UNITED STATES PATENT AND TRADEMARK OFFICE

APPLICATION NO.	FILING DATE	FIRST NAMED INVENTOR	ATTORNEY DOCKET NO.	CONFIRMATION NO.
10/663,757	09/17/2003	Eiji Hayashi	Q77556	3827

Office Action Summary

DETAILED ACTION

Fig. 3

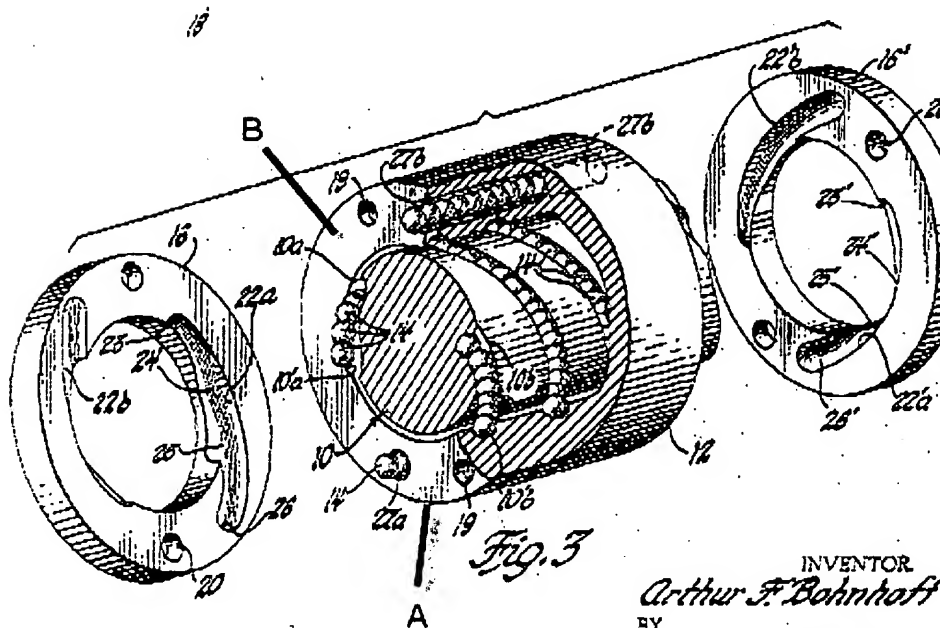
- Two screw grooves are respectively formed as multiple thread screws (10a,10b) and one of the side caps (16) is disposed on each of the multiple threads (10a, 10b see figs 2 and 3).
- Wherein the side cap (16) further comprises a pair of ball scooping up portions (see ball circulation passage, both sides, at 23) and a cap main body (16)
- Wherein the nut further comprises an axial end surface (see figure 3 below (B)), and the circumferential outer surface is a cylindrical surface extending perpendicular to the axial end surface.

3. Third, claim 2 sets forth that the nut comprises an axial end face, and a cylindrical outer circumferential surface extending perpendicular to the axial end face. Further, claim 2 sets forth that the side cap is disposed on that cylindrical outer circumferential surface. In contrast to that set forth in claim 2, Bohnhoff discloses a cap 16 mounted on the axial end face of the nut. Because claim 2 sets forth both an axial end face and a cylindrical outer circumferential surface, the Examiner's previous interpretation of Bohnhoff's axial end surface as the outer circumferential surface is now not appropriate.

- a. In response, Claims 1, 2, 4, 16, and 19 have been withdrawn as being drawn to a non-elected species. Furthermore, a marked up copy of figure 3 has been included which more clearly points out an axial end face (A) and a circumferential surface (B)

4. Fourth, claim 15 sets forth at least one side cap including a ball circulation passage substantially extending in a longitudinal direction of the screw shaft. In contrast to that set forth in claim 15, Bohnhoff discloses ball circulation passages 22a, 22b that extend in a direction perpendicular to the longitudinal direction of the screw shaft.

- a. In response, the examiner notes that Bohnhoff clearly discloses a ball circulation passage that extends in a longitudinal direction of the screw shaft (C3/L1-30). The balls are clearly shown extending from the nut into the side cap, thus the ball circulation passage extends in a longitudinal direction of the screw shaft as claimed.
